Planning Commission Meeting Packet

July 12, 2016

COVER MEMO
SP 16-04
Sherwood Plaza Apartments

To: Planning Commission
From: Michelle Miller, AICP Senior Planner
RE: SP 16-04 Sherwood Plaza Materials for July 12, 2016 continued Hearing
Date: July 5, 2016

Exhibit J

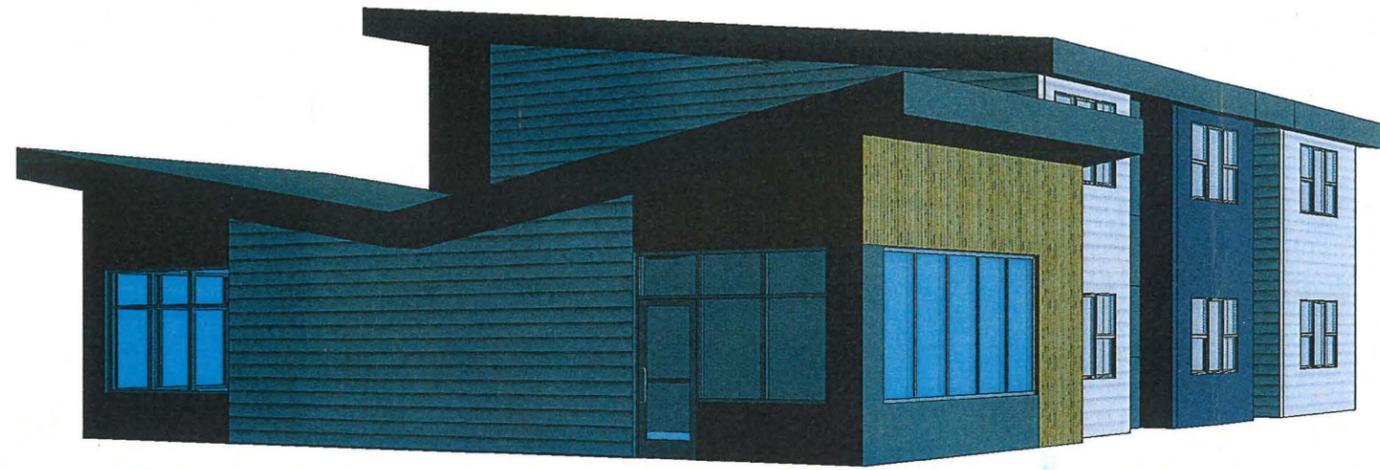
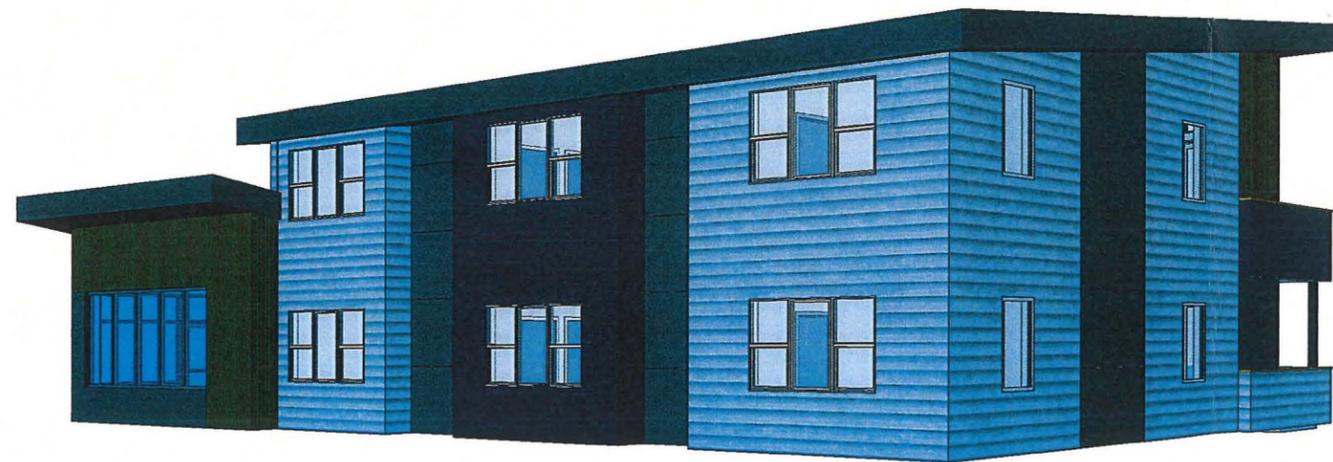
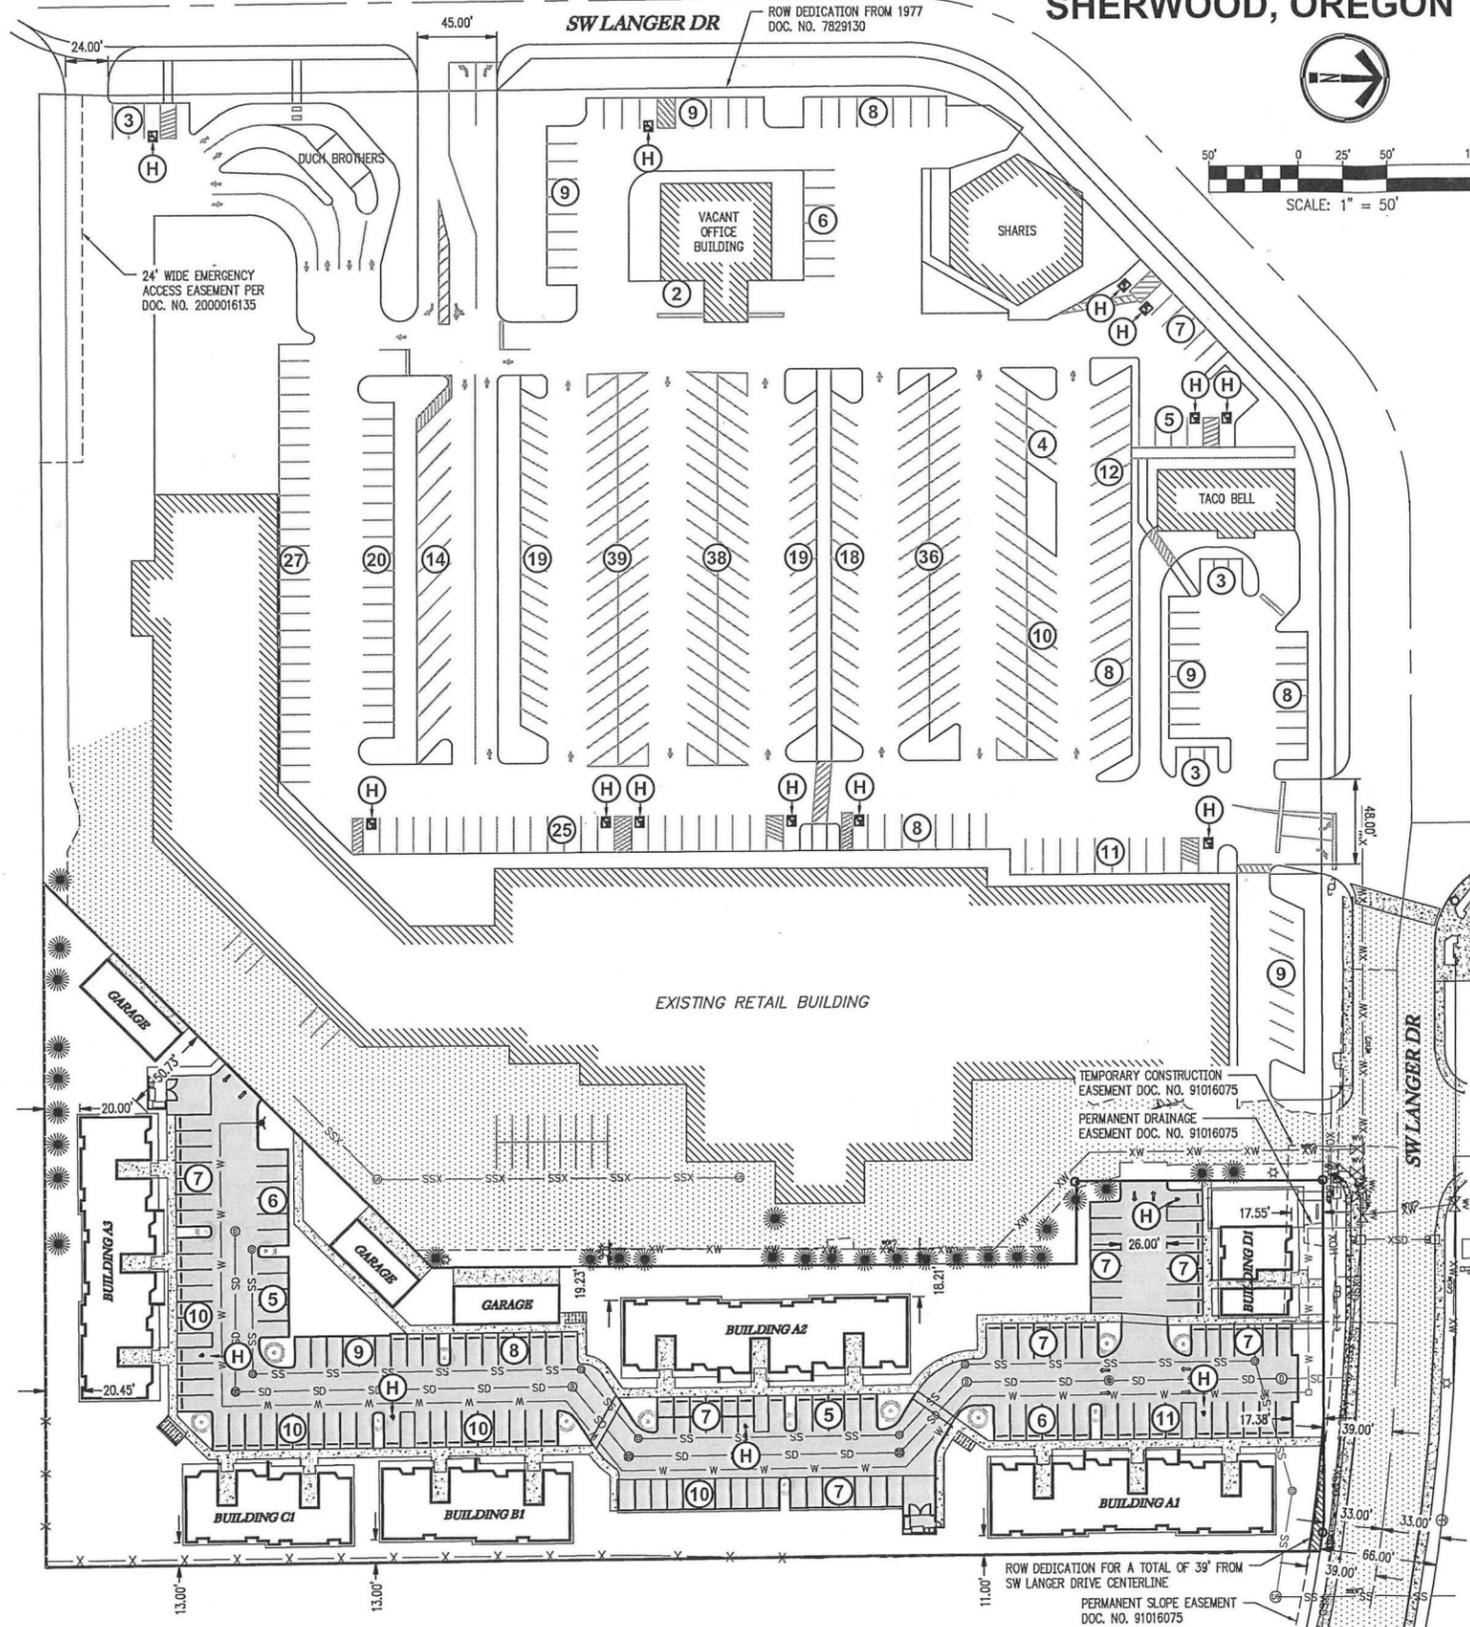
The other building using the front yard setback of SW Langer Drive to the north, "Building A" has a side elevation that directly faces northern SW Langer Drive, with a 28 foot setback. Building 1 and 2 are flush with SW Langer Drive on the north and need to be oriented to the street. The applicant shows a side elevation at this location rather than a front elevation for Building 2, with limited articulation and orientation to the pedestrian. The applicant will need to revise this elevation in order to meet the intention of this standard.

Planning Commission Discussion: The applicant submitted additional information on addressing this criterion. (Exhibit I). The applicant proposes a pedestrian plaza with additional streetscape amenities along the frontage of the apartment complex portion of SW Langer Drive. These include a different colored sidewalk treatment, trees, benches, and concrete planter boxes and a short wall. This will bring activity to the front of the area and will break up the building façade on the street facing elevation.

The applicant noted in their testimony that the street facing elevation of building 1 had different fenestration, but was not shown on the submitted plans. The additional design elements satisfy the condition with respect to building 1.

RECOMMENDED CONDITION: Prior to final site plan approval, provide revised elevations for the northern sides of Building ~~s-1 and-2~~ which front SW Langer Drive. The elevations shall clearly demonstrate how the ~~buildings-building are-is~~ located and oriented to the street, and ~~have-has~~ significant articulation and treatment, via facades, sidewalk connection, porticos, arcades, porches, portal, forecourt, or stoop to identify the entrance for pedestrians.
